**Public Works Subcommittee
Meeting on 14 April 2010**

**List of issues requiring follow-up actions by the Administration
before the Finance Committee meeting on 30 April 2010**

The proposed part-upgrading of **13GB** is to provide a village resite area with supporting infrastructure at Ta Kwu Ling for reprovisioning of the existing Chuk Yuen Village. This is the first step of the project for the development of Liantang/Heung Yuen Wai Boundary Control Point (BCP) which will only proceed after the completion of the reprovisioning of the village to the resite area. In respect of the detailed design and construction of the BCP itself and the associated new connecting road, we will consult the relevant LegCo Panels and submit funding applications separately at a later date when we are ready to take forward the implementation of the project.

13GB (PART) - LIANTANG / HEUNG YUEN WAI BOUNDARY CONTROL POINT AND ASSOCIATED WORKS -
VILLAGE REPROVISIONING WORKS - SITE PLAN

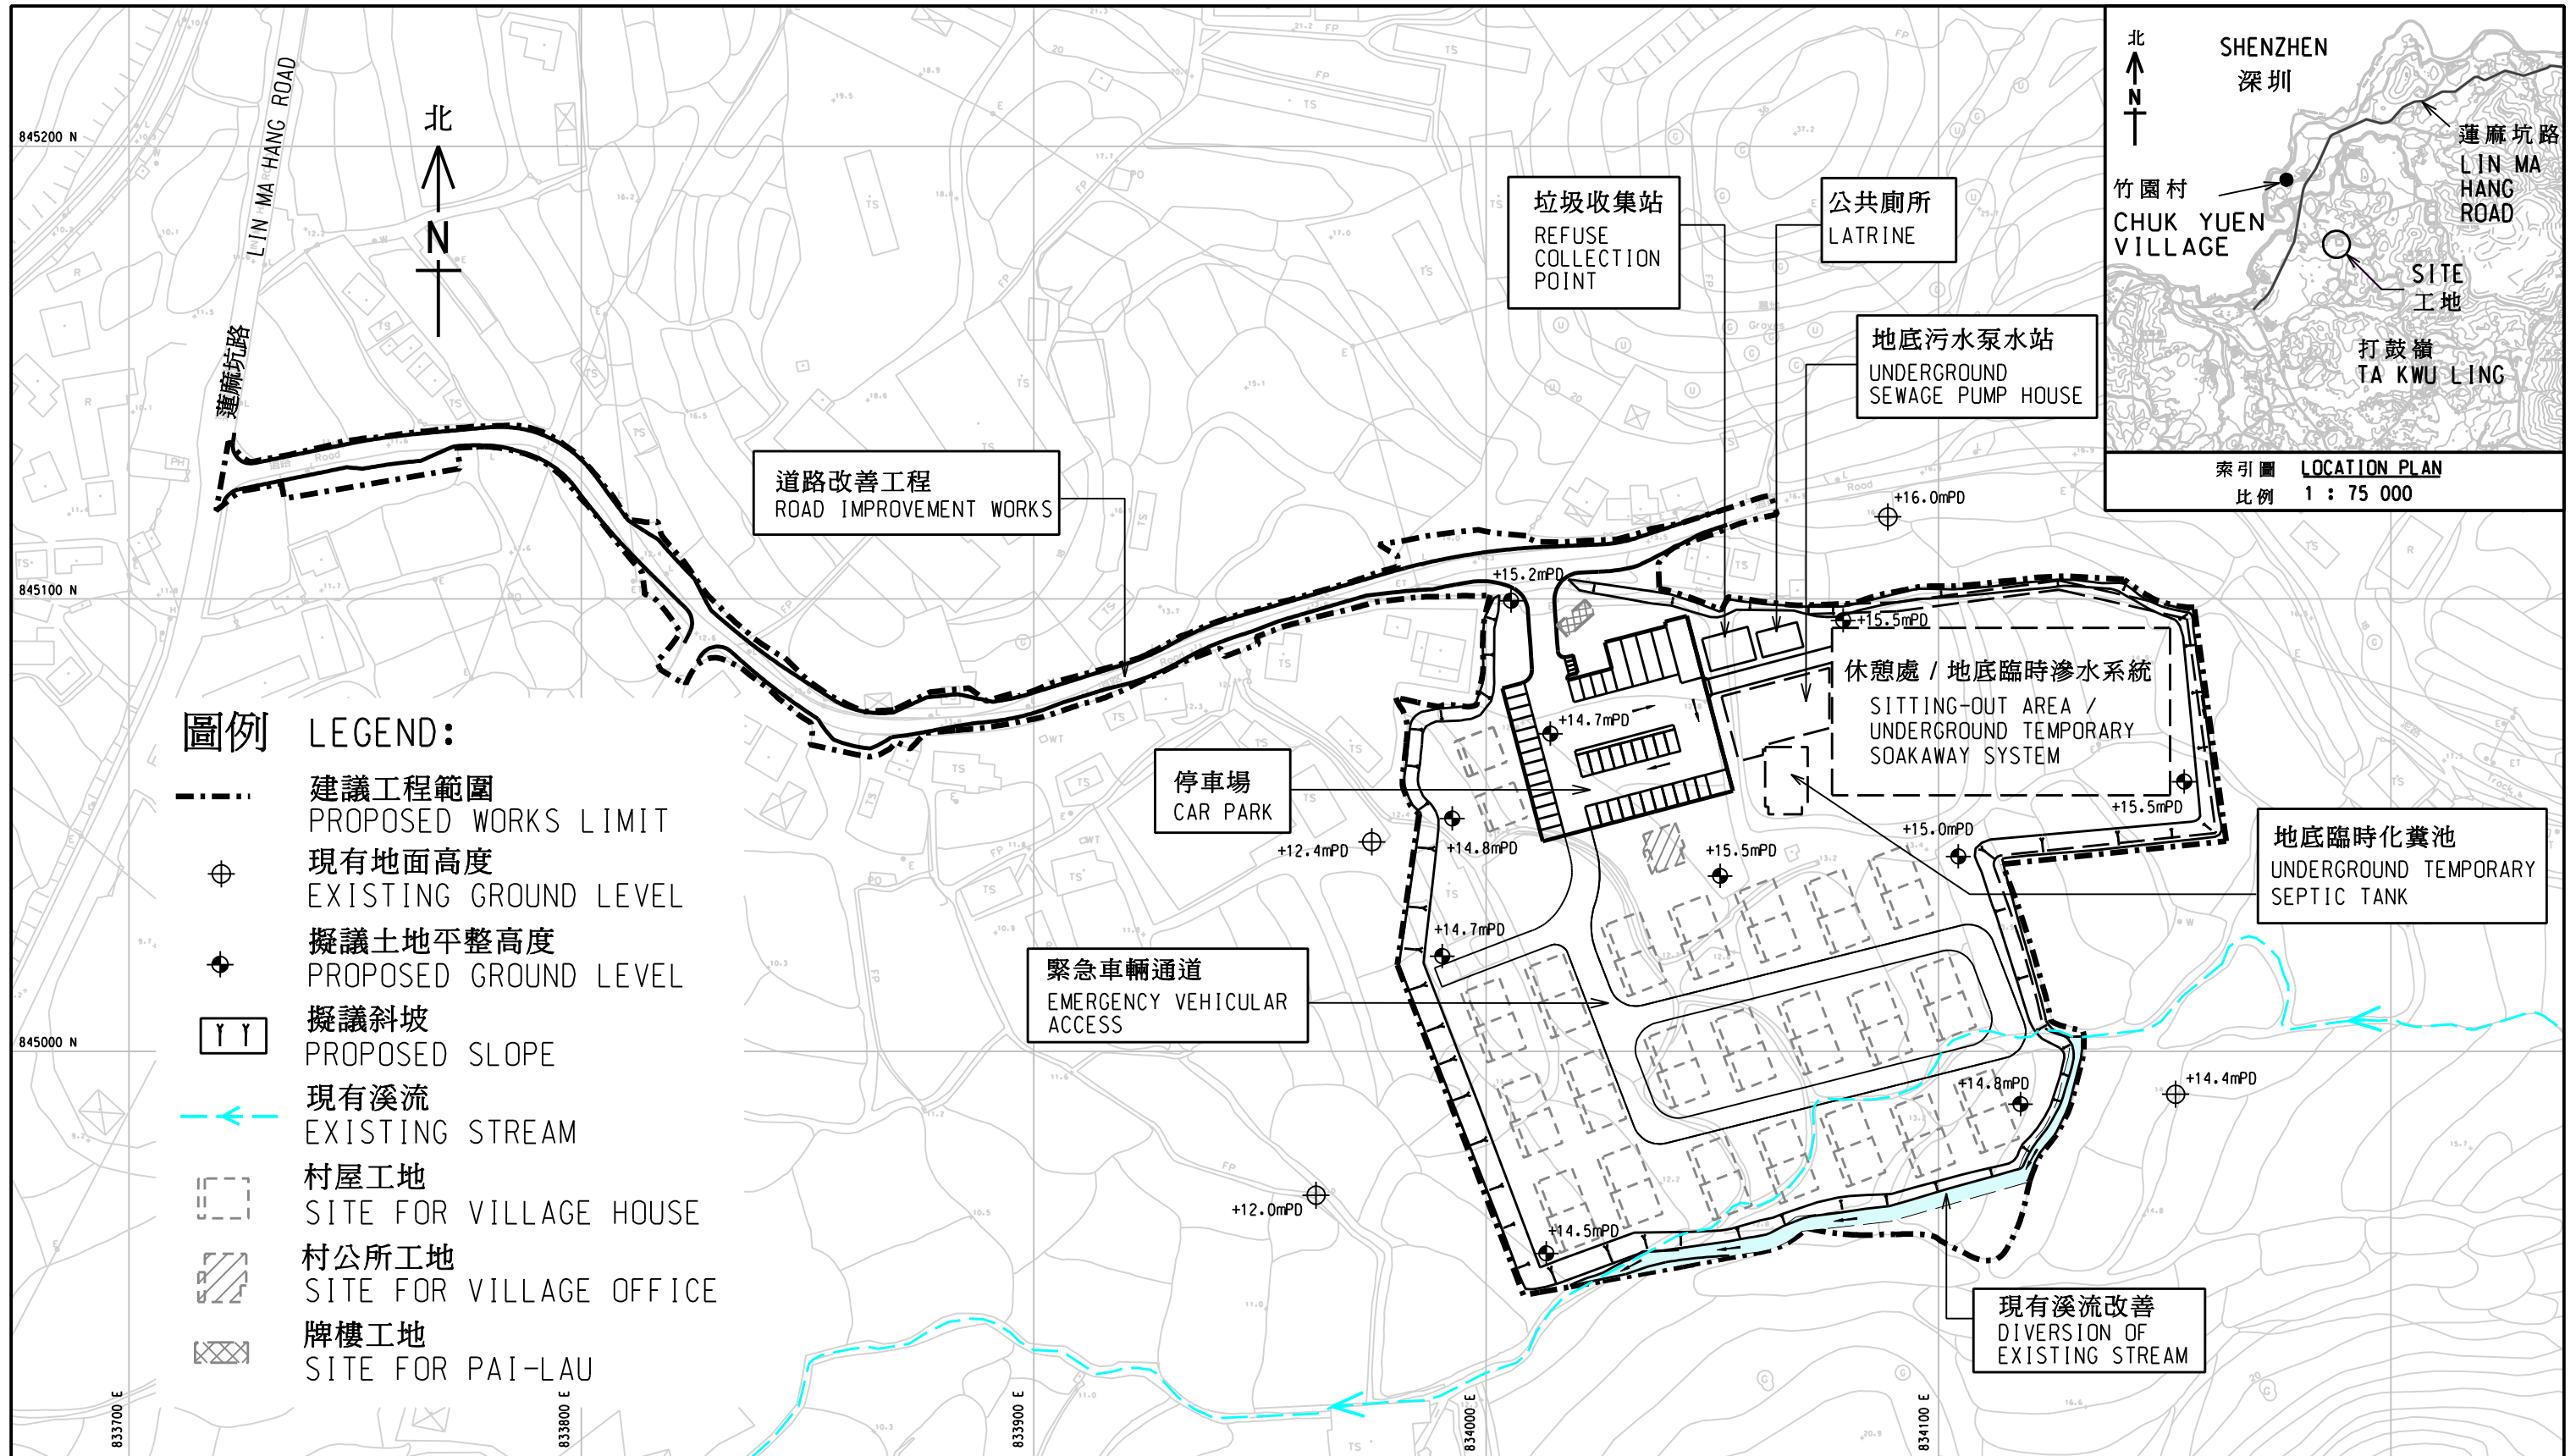
At the request of Prof Hon Patrick LAU, the Administration agreed to beef up the site plan at Enclosure 1 to PWSC(2010-11)2 to show the village houses and other public facilities at the resite area.

A plan showing the layout of the village houses and other public facilities is at **Enclosure 2**. We have had many rounds of discussions and exchanged views with the Chuk Yuen Village Removal Committee since 2009 in regard to the layout and ancillary facilities of the resite area, including site selection, site formation and stream diversion, disposition and orientation of the village houses. The layout was firmed up after discussion and agreement of the Village Removal Committee.
